19 September 2016

**RE: BETTER APARTMENTS DRAFT DESIGN STANDARDS**

Figure 1 – Comparison of draft design guideline side/rear setback outcomes against that existent in Port Phillip DDO26 (St Kilda Road North) and proposed for the Central City under DDO10 (Melbourne Amendment C270).

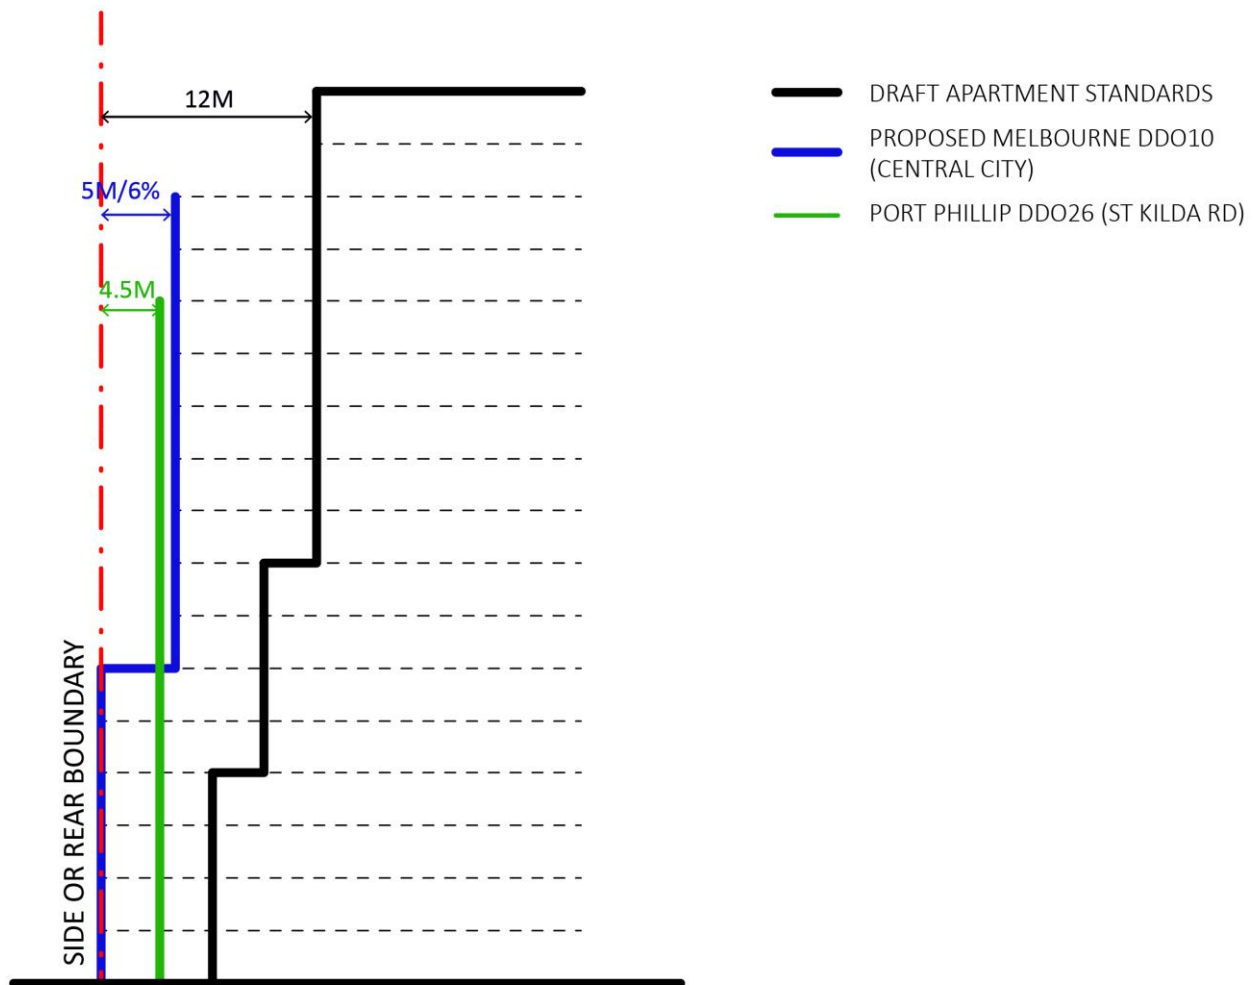
This is the most pertinent of the exhibited Standards with respect to urban design, and – as exhibited – will have a significant impact on the development capacity of an area. Whilst we understand that site-specific planning policy (such as DDOs and Structure Plans) will overrule the exhibited guidelines, consideration should be given to incorporating a different 'lesser' standard in areas where significant growth is anticipated (such as in urban renewal areas and commercially/RGZ zoned land). Doing so would be consistent with aspects of Melbourne Amendment C270 (DDO10) and Port Phillip C107 (DDO26) – both of which apply to state-significant areas. Refer overleaf.
